Access Compliance Report Public Rights-of-Way (Curb Ramps)

Main Street: FAIRHAVEN_AVE Cross Street: S_WOODLAND_ST Location: NW

ADA ID: RPRK211007114309 Ramp Type: Type 1 - Perpendicular Diagonal Initial Pass/Fail: Fail Overall Compliance: No Severity Score: 2

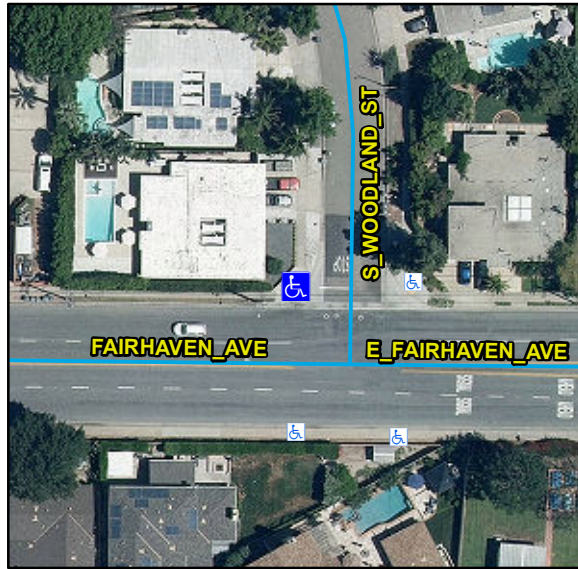
R304.2.2, R304.5.3, STD 1115

Remove & Replace Curb Ramp With Two New Directional Ramps or Equivalent.
